Rezoning Review Briefing Note | Planning Proposal (PP 2021-7146) Part Sub Precinct 5, South Creek West Land Release Area, Cobbitty – Bringelly

1 Overview

Figure 1 Post-Development Flood Depth Levels

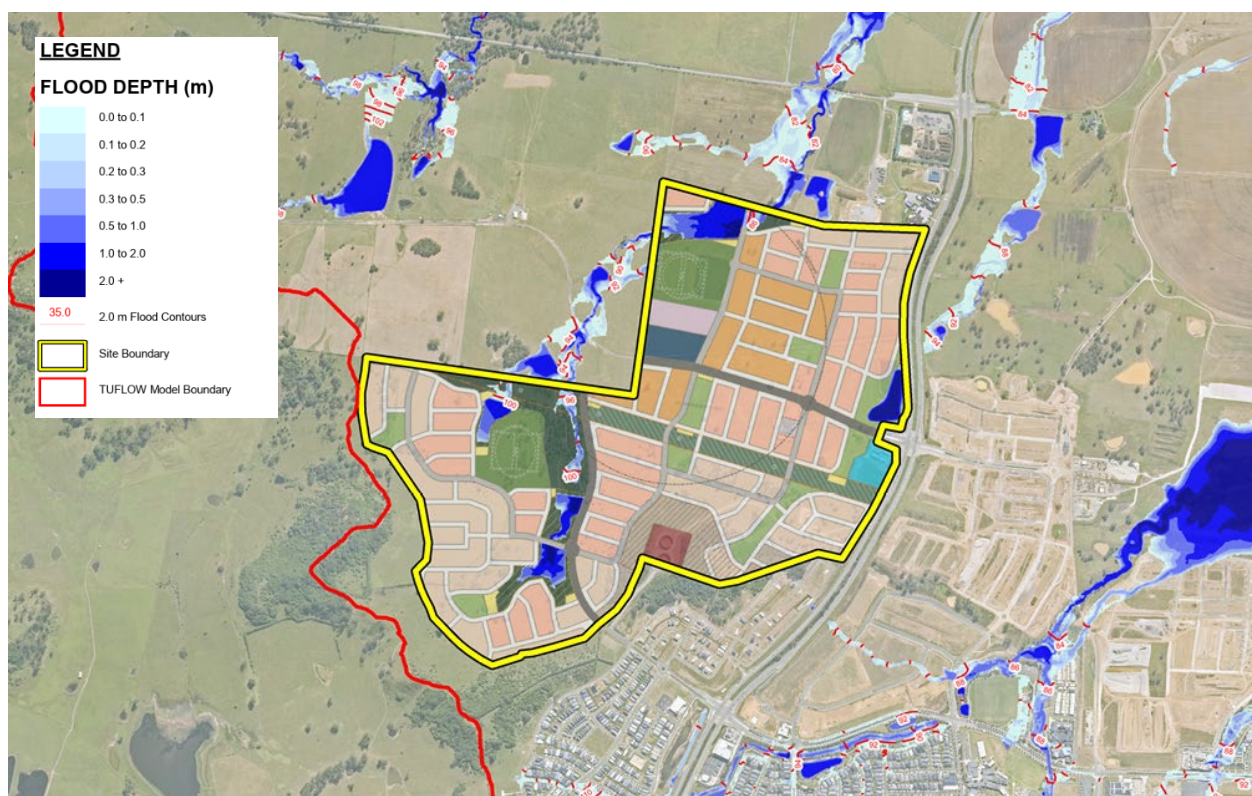
As part of the additional assessment and redesign of the ILP, additional TUFLOW Modelling has been undertaken by JWP to assess flood, and stormwater impacts on the site. This re-assessment has also considered the revised basin strategy.

All flooding impacts will be contained within the riparian corridor, as well as within the 0.9804ha waterbody in Open Space 3 on the eastern boundary of the site along the Northern Road.

JWP in their Stormwater Advice Letter (**Appendix D**) has confirmed the above findings and notes that the updated Water Cycle Management Strategy is in alignment with the August 2025 ILP and is currently being prepared.

Figure 2 Riparian Corridor Offset Plan

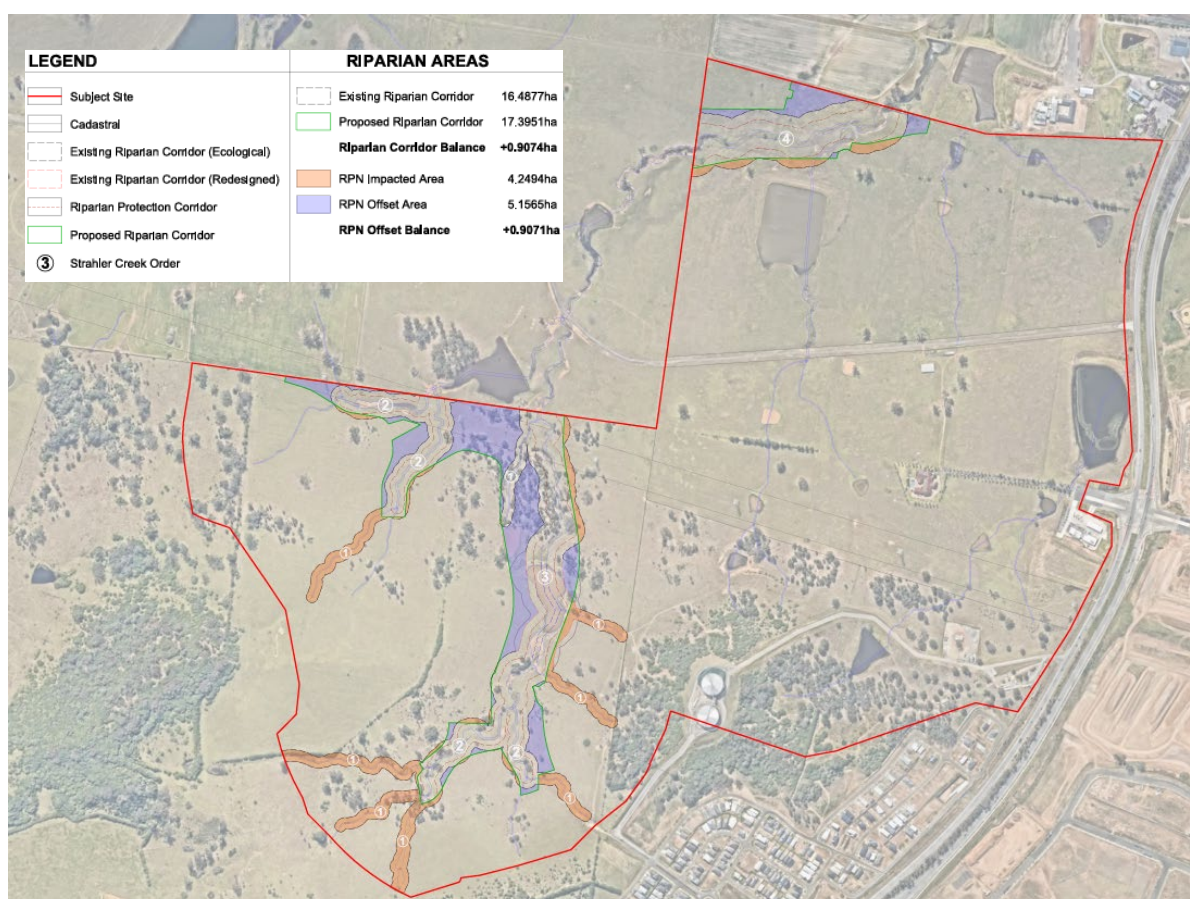
These investigations have informed the finalisation of the redesign of the riparian corridor within the ILP. As a result, the redesign results in an offset balance of +0.9071ha of additional riparian corridor land. Design + Planning have prepared a Riparian Corridor Offset Plan, demonstrating the offset Outcome reached within the updated ILP. An excerpt is shown below.

JWP in their Stormwater Advice Letter (**Appendix D**) note that the updated Water Cycle Management Strategy will ensure that the basins strategy preserves the third order water courses on the site.

Figure 3 Residential Density Map

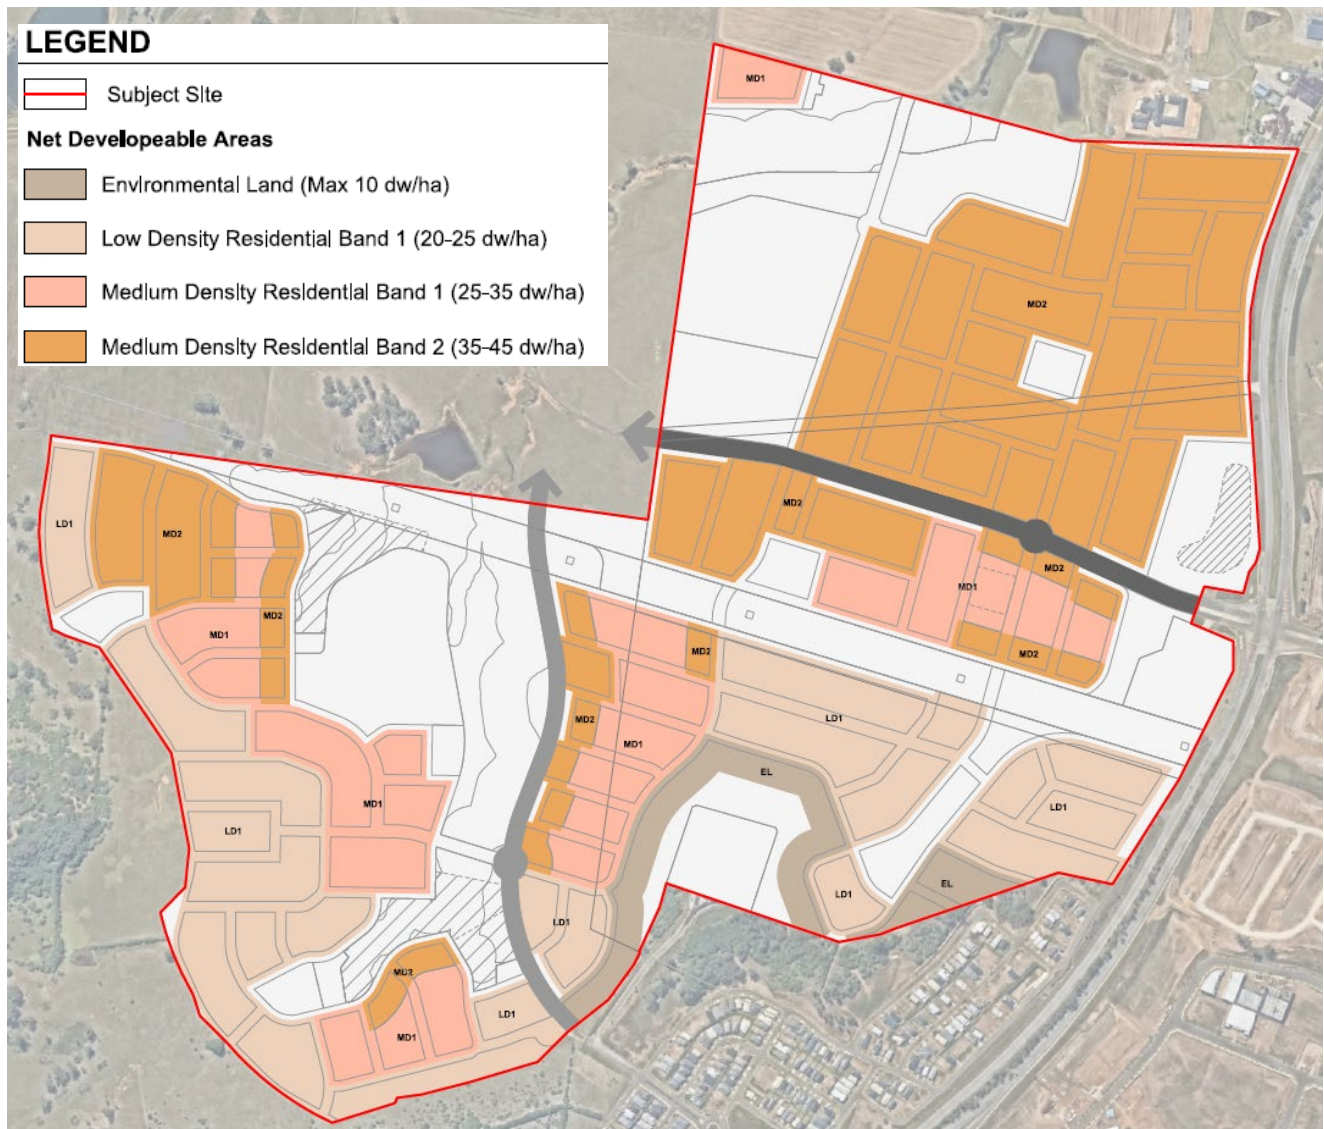
The Residential Densities have been calculated on an NDA of 103.54ha, which results in a site average of 31 dw/ha, yielding 3,197 residential lots.

An excerpt from the updated Residential Density Map, prepared by Design + Planning, is provided below.
